# Access Compliance Report

## Public Rights-of-Way

Intersection ID: 50736	Main Street: JONES RIDGE DR	Cross Street: PROVIDENCE LN WEST	Location: N
ADA ID: 450FC5D8E665	Ramp Type: PerpDiag	Initial Pass/Fail: Fail	Overall Compliance: No
Severity Score: 21.25			
Codes/Mitigation Info/Possible Solution		Field Measurements/Component Compliance

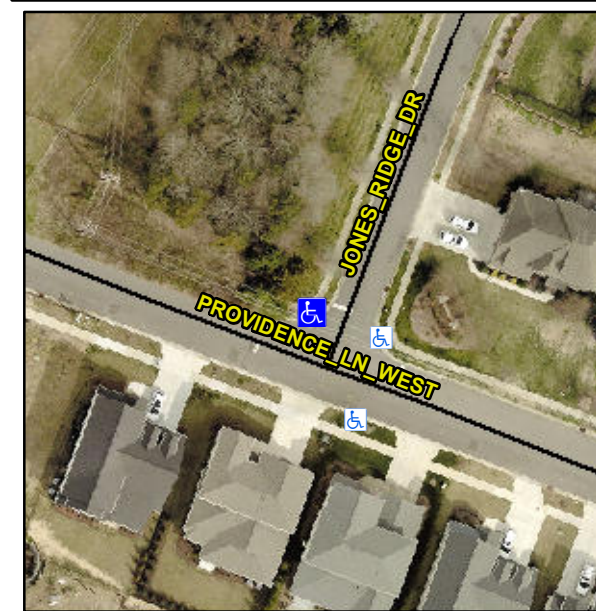
**Not Found, R304.5.1, R304.5.3**

Compliance	Description	Data	Compliance	Description	Data
N/A	Ramp Length (in)	44.0	Yes	Ramp Slope (%)	5.7
No	Ramp Width (in)	39.0	No	Ramp XSlope (%)	5.4
N/A	Flare Type LT	N/A	N/A	Flare Type RT	N/A
N/A	Flare Slope LT (%)	N/A	N/A	Flare Slope RT (%)	N/A
N/A	Flare Traversable LT?	N/A	N/A	Flare Traversable RT?	N/A
N/A	Landing Length (in)	N/A	N/A	DWS Provided?	N/A
N/A	Landing Width (in)	N/A	N/A	DWS Contrast?	N/A
N/A	Landing Slope (%)	N/A	N/A	DWS Length (in)	N/A
N/A	Landing X Slope (%)	N/A	N/A	DWS Full Width?	N/A
N/A	Landing Curb? (Y/N)	N/A	N/A	DWS Offset (in)	N/A
N/A	Shared Landing?	N/A			
N/A	Gutter Ponding?	N/A	N/A	Gutter Slope (%)	N/A
N/A	Gutter Lip Ht (in)	N/A	N/A	Gutter X Slope (%)	N/A
N/A	Painted X Walk1?	No	N/A	Painted X Walk2?	No
	X Walk 1 Direction	To SW		X Walk 2 Direction	To SE
N/A	X Walk 1 Width (in)	N/A	N/A	X Walk 2 Width (in)	N/A
	X Walk 1 Slope (%)	0.0		X Walk 2 Slope (%)	3.1
	X Walk 1 X Slope (%)	1.9		X Walk 2 X Slope (%)	4.9

**Remove & Replace Curb Ramp With Two New Directional Ramps or Equivalent.**
